RECEIPT DATE: 7/14/14 **ONSITE SEWAGE DISPOSAL SYSTEM**

PROPERTY ADDRESS: 13026 High Grove Road

SUBDIVISION: Schooley Mill Farm LOT: 6 TAX ID: _____

SCHOOLEY MILL FARM
SITE PLAN FOR BAT INSTALLATION
FOR LOT 6

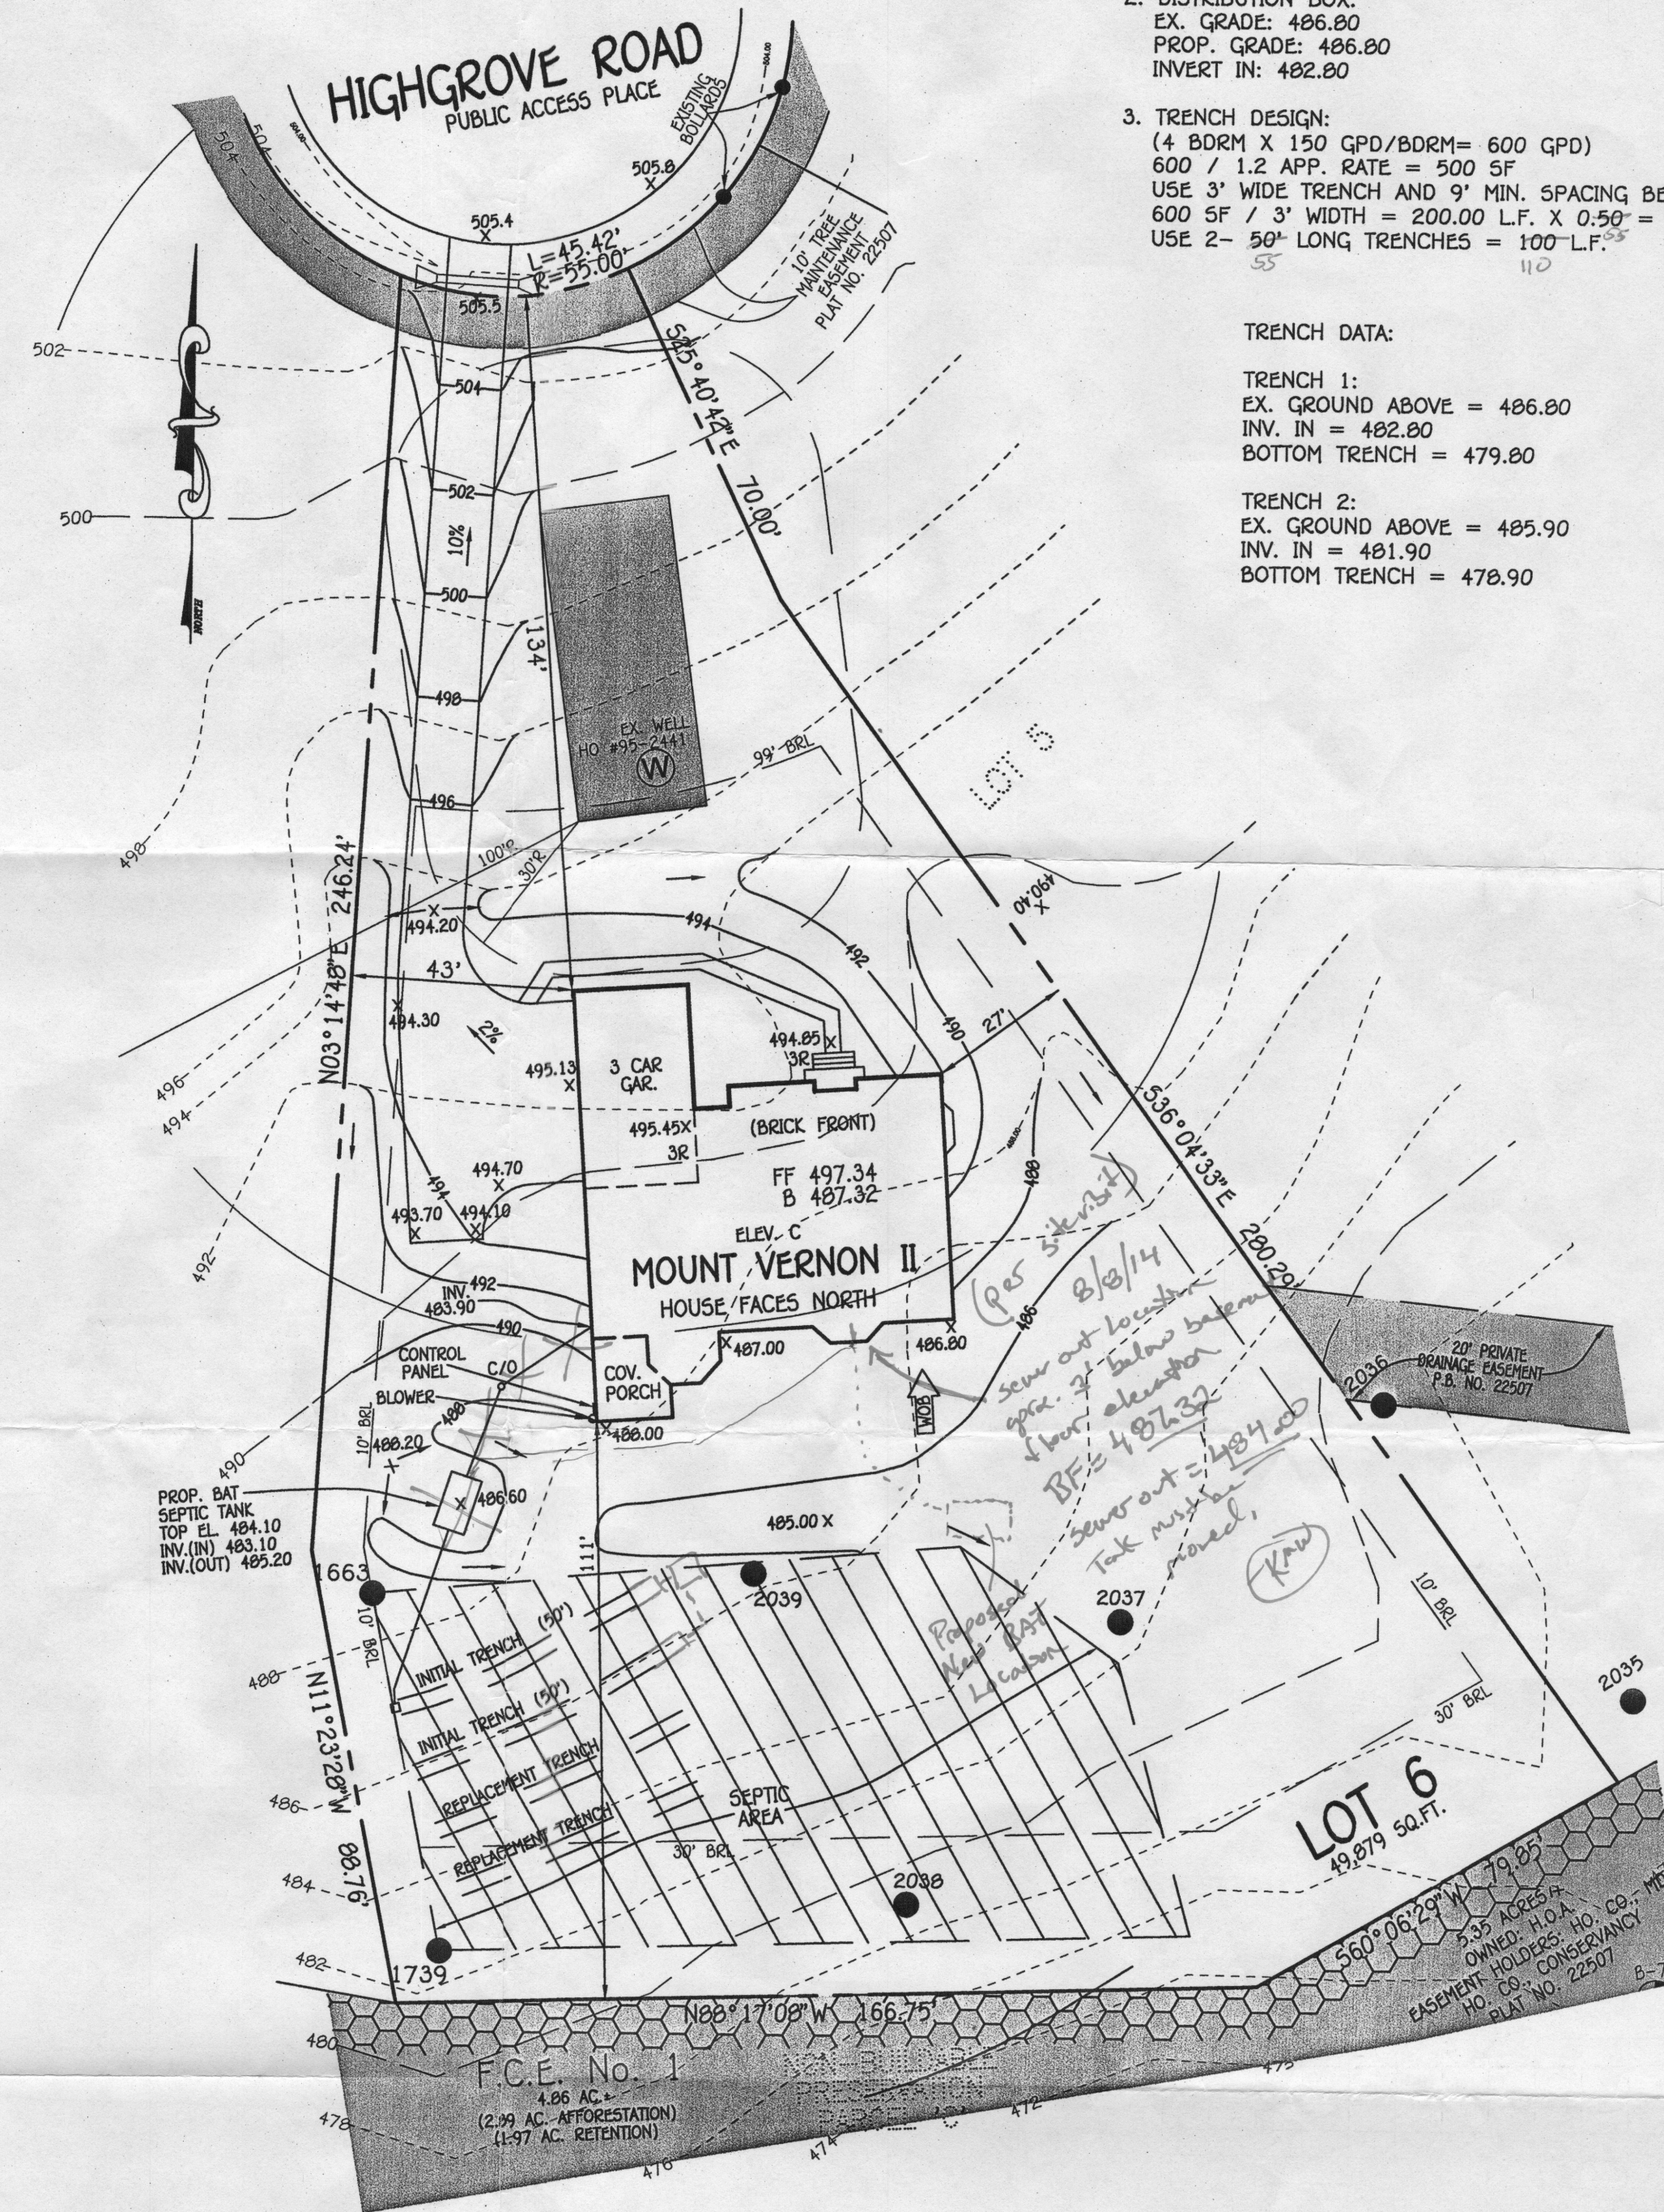
Otherwise, for all lots the approved trench bottom depth is 7', but on all you have trench bottom depths at 8'. Also, we need the trench invert elevations for all. We also need the trenches within each system to be exactly equal length. I don't think that will be a problem on any of these. What is helpful to us is to include a chart or note indicating the trench depths and specs. I've attached a copy of an example that we like.

- All of the plans need to show the pump on elevation and dose volume.
- All plans need to show trench details: ground elevation, invert elevation, bottom elevation for each.
- Lot 6: hoot tank location is in the middle of a proposed swale. They could move it over right by perc hole 1663.
- Lot 7: the building permit states 5 bedrooms, you revised the plan down to 4 bedrooms
- Lot 9: the sewer grade states 7%, but is really 4.7% (FYI, anything greater than 5% should level off to 2% in the last few feet before the tank)
- Lot 9: the d-box should go at the top edge of the easement for an end feed to the trenches.
- Lot 4: the d-box should go to the corner of the easement for end fed trenches.

SEPTIC SYSTEM PROFILE
SCALE: HORIZ. 1" = 30'
VERT. 1" = 3'

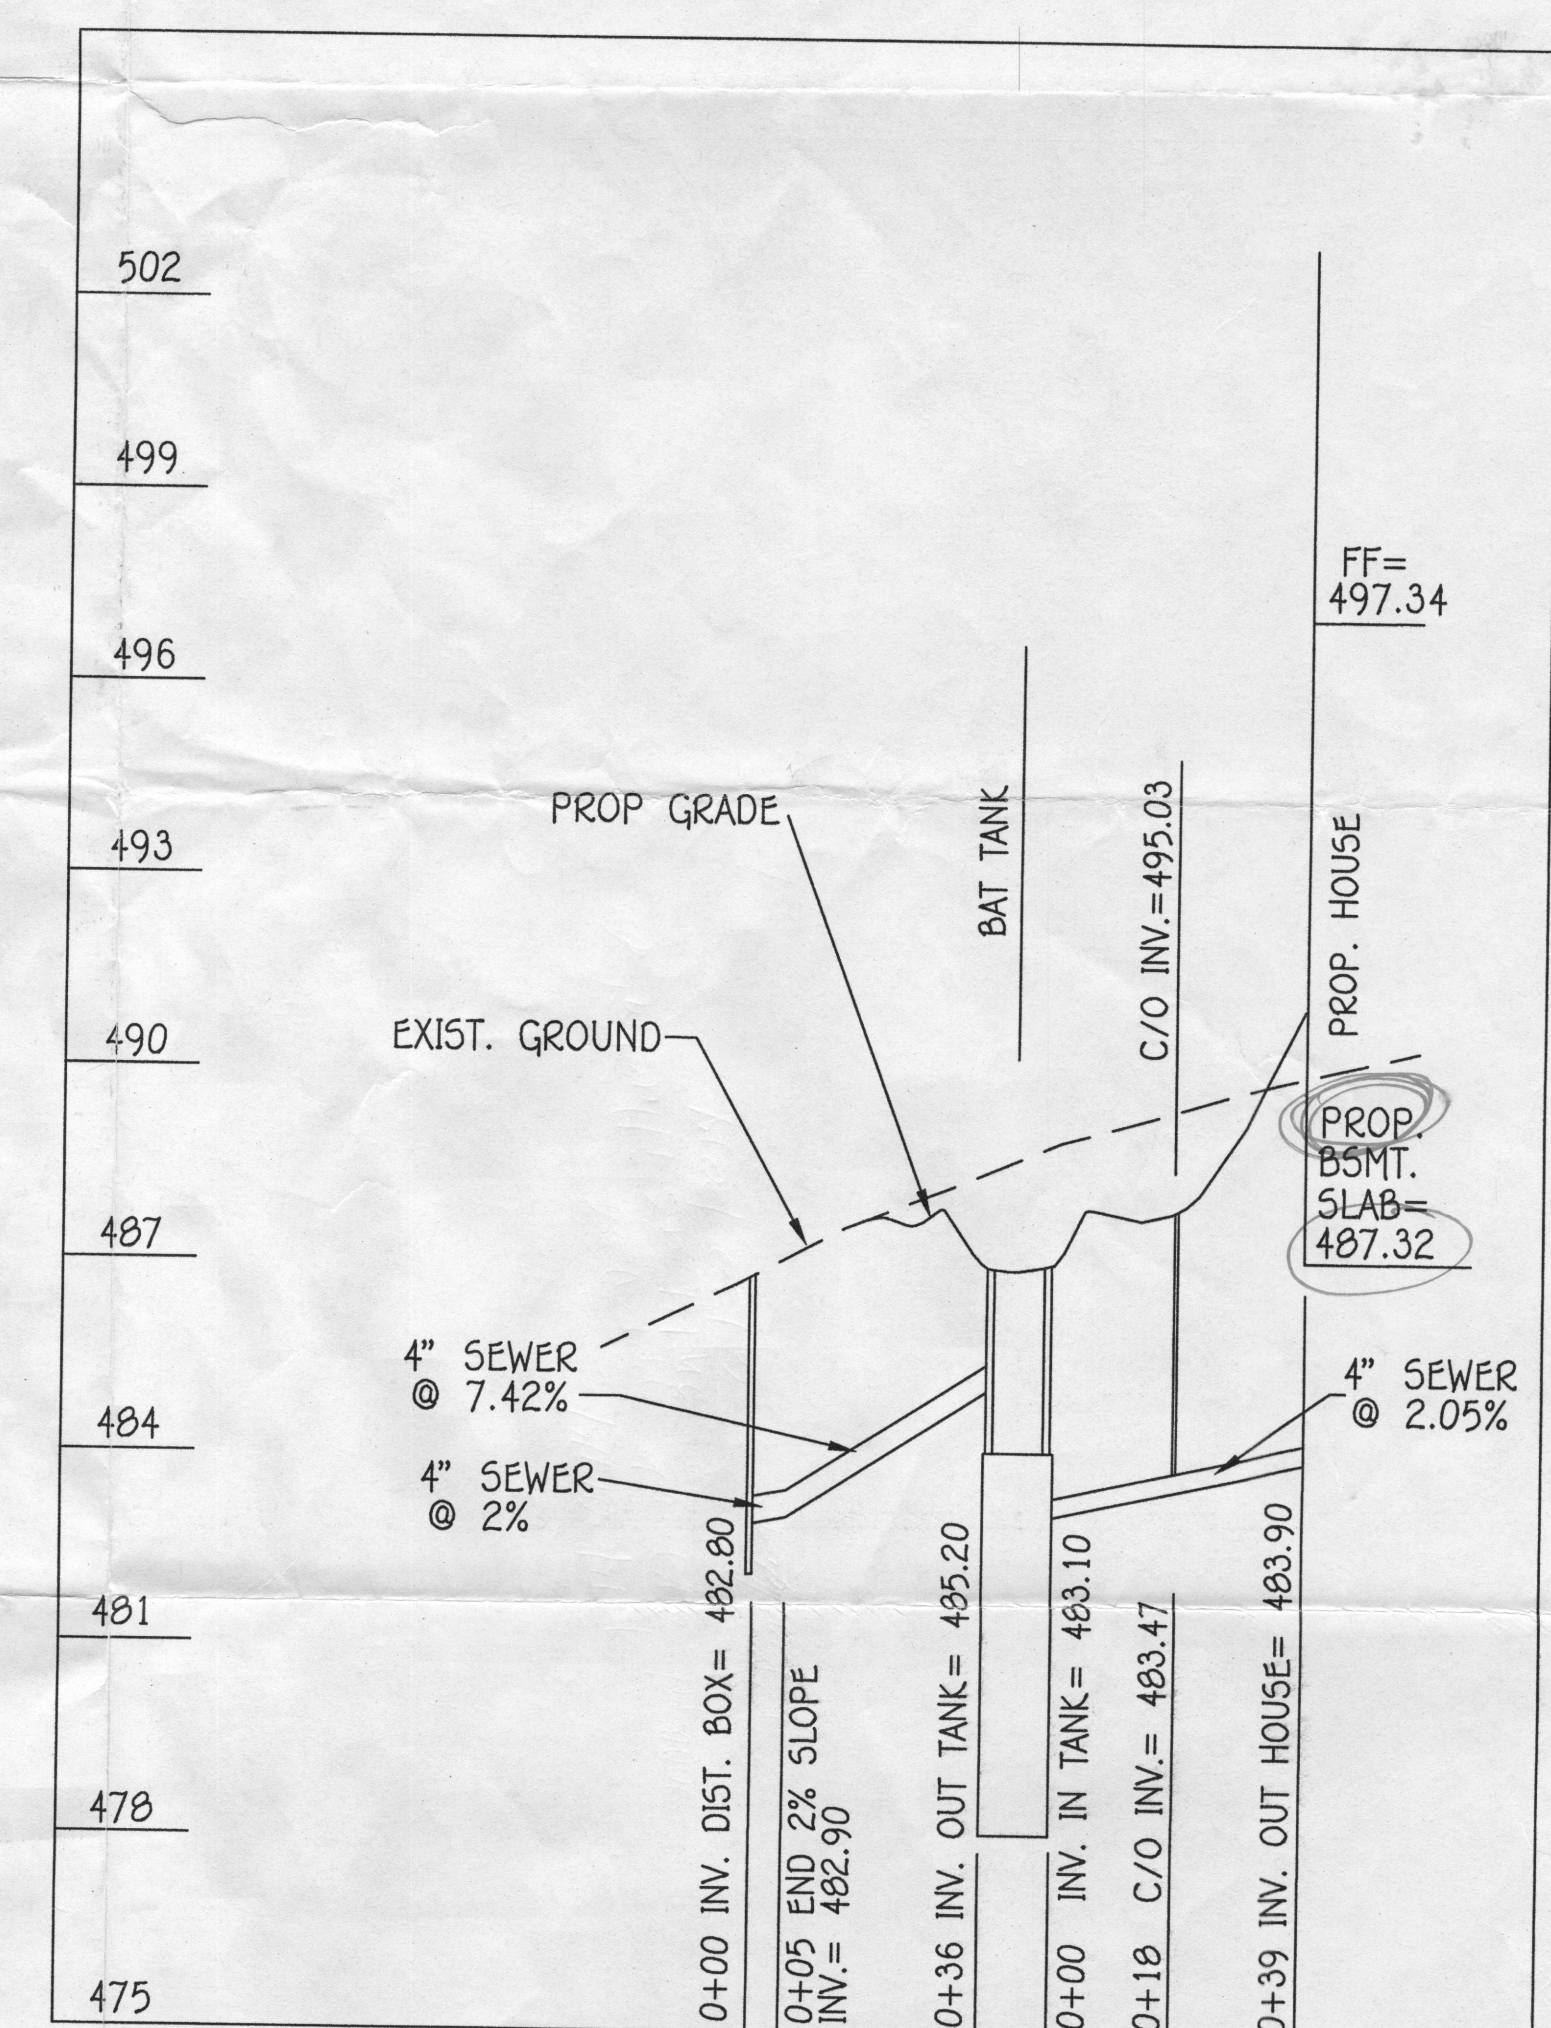
For lot 6, it looks like on the site plan that you moved the proposed graded swale over to keep the tank on the side slope, but the septic profile still shows the proposed grade with the swale directly over the tank. I think the profile may need to be updated to match the new proposed grading?
